re: Preliminary Geotechnical Review - Proposed SWMP
Proposed Residential Development
Cardinal Creek Village South – Ottawa, Ontario

to: Taggart Investments - **Ms. Michelle Taggart** - mtaggart@taggart.ca
to: HP Urban Inc. - **Mr. Peter Hume** - peter.hume@hpurban.ca
to: DSEL - **Mr. Braden Kaminski** - Bkaminski@dsel.ca
date: December 2, 2022
file: PG5201-MEMO.01 Revision 2

POND OUTLET SECTION
N.T.S.

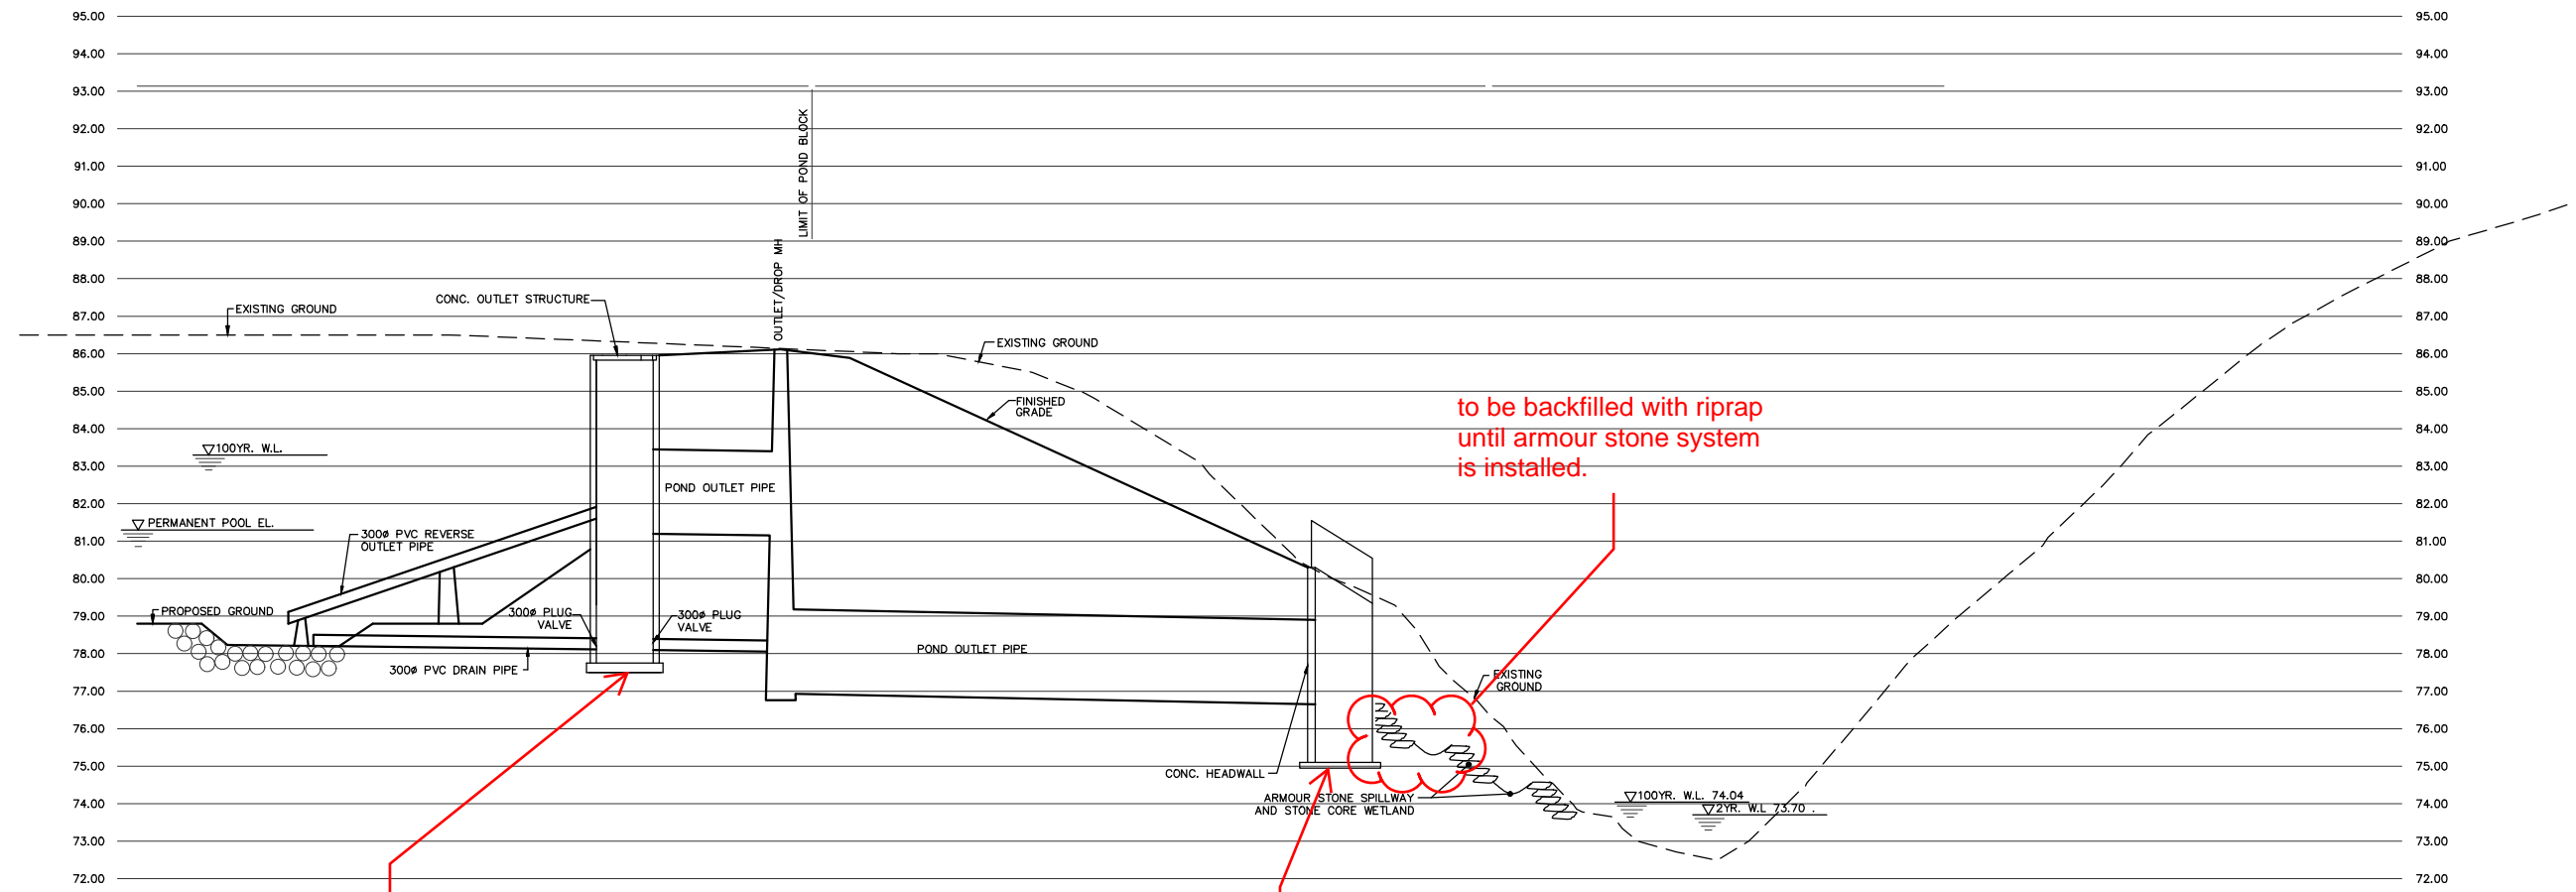
Paterson Notes: Bearing medium expected to be Stiff Grey Silty Clay and/or Glacial till.

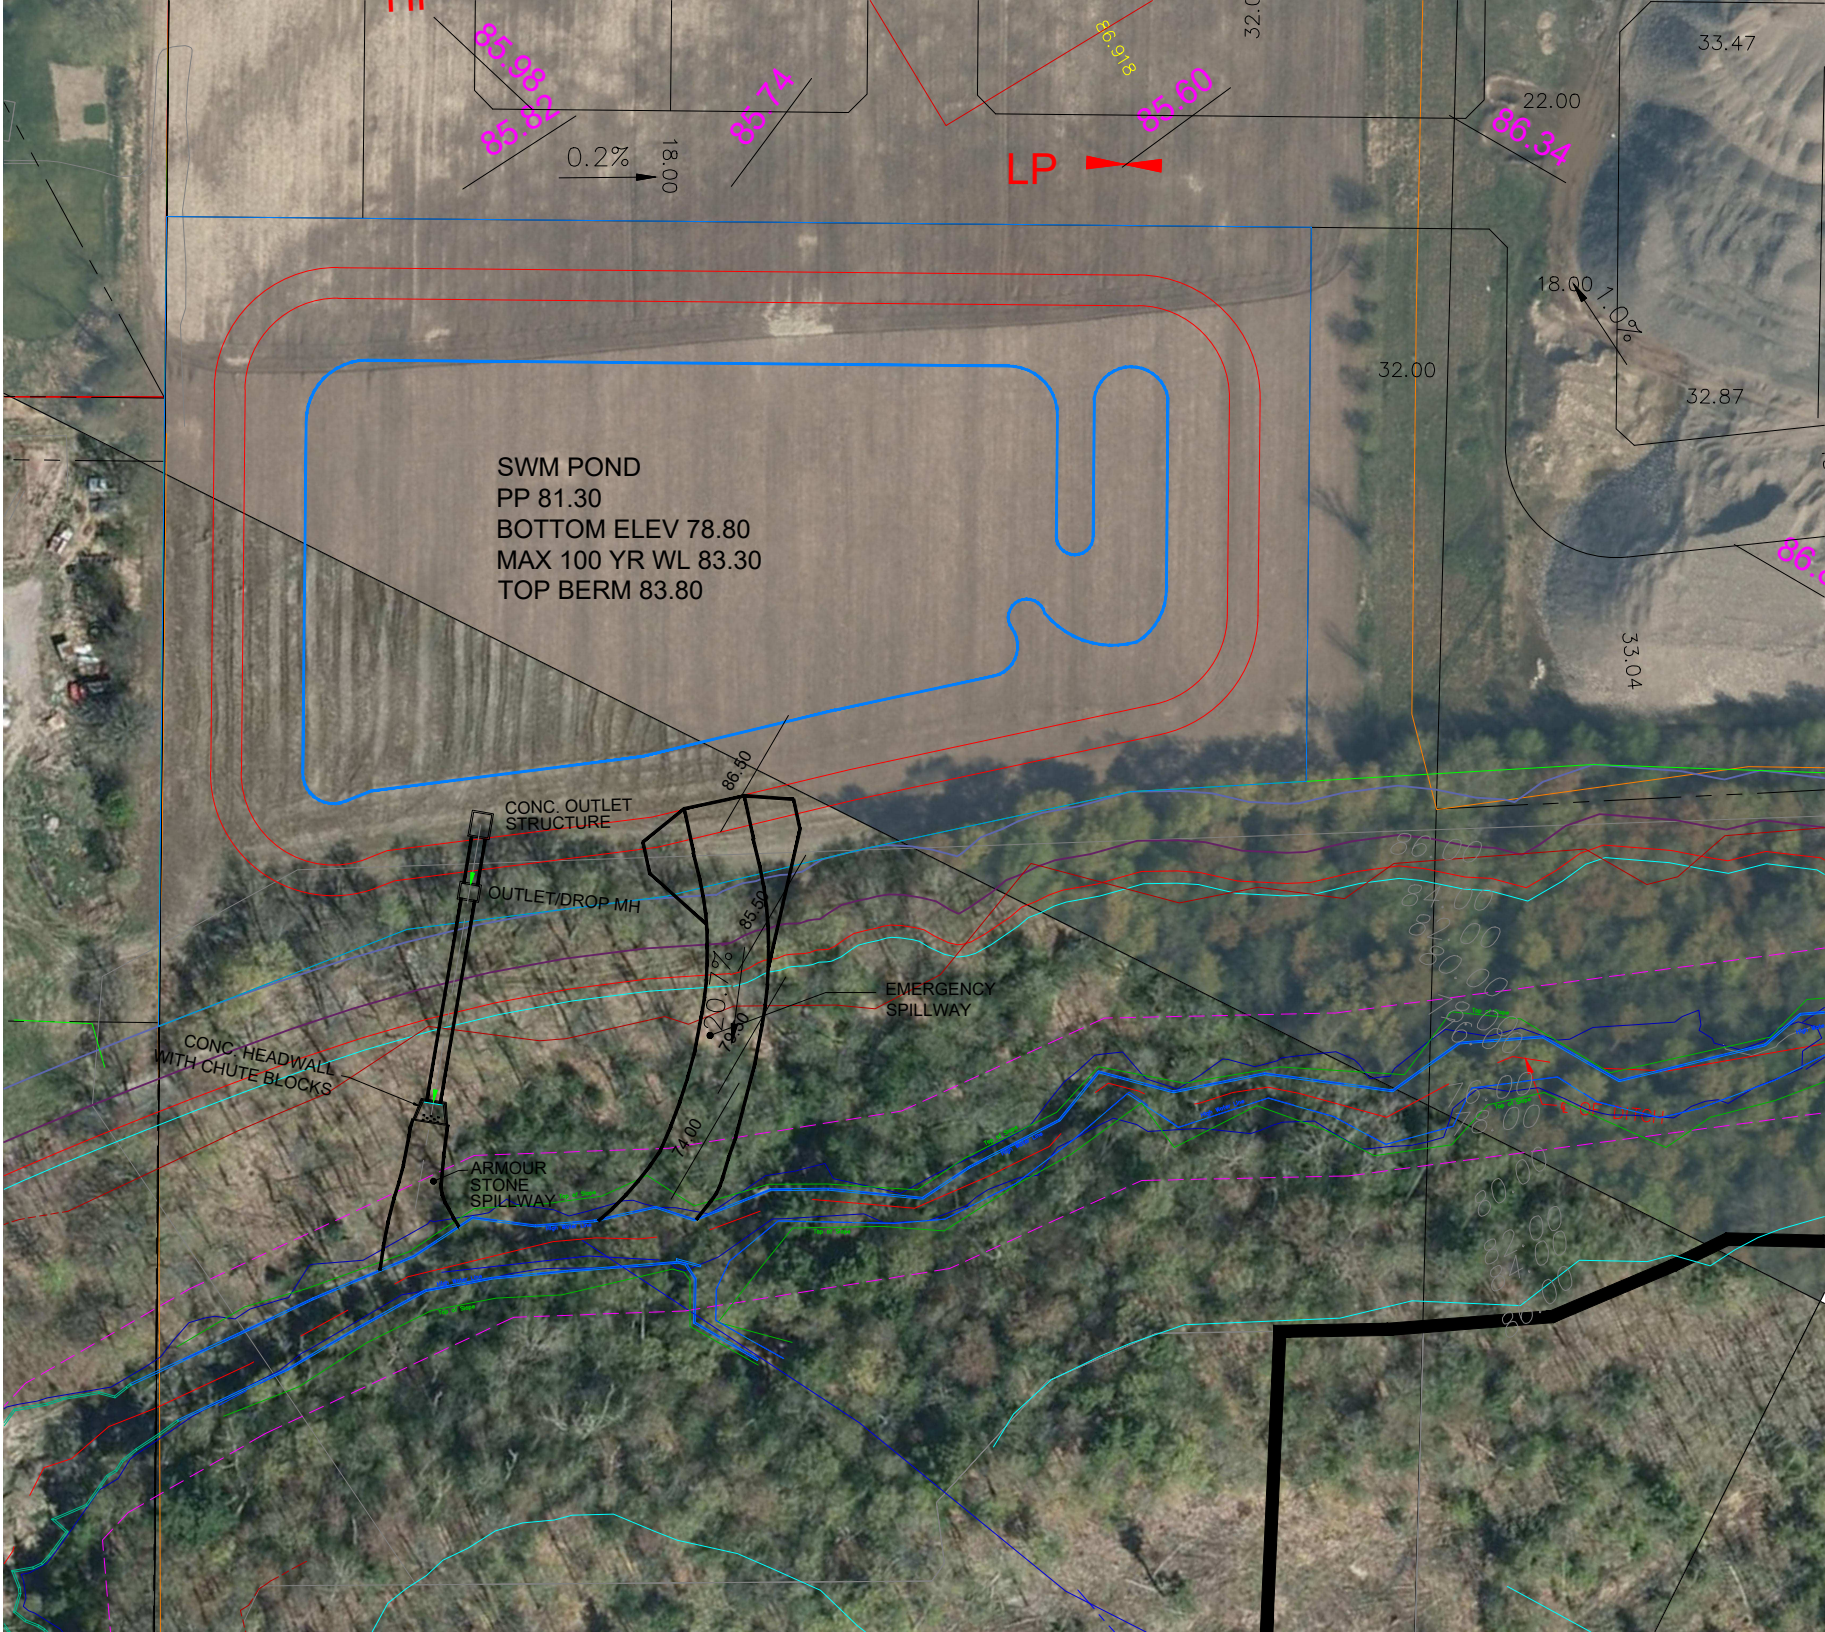
Paterson Notes: Bearing medium expected to be glacial till over bedrock and/or bedrock.
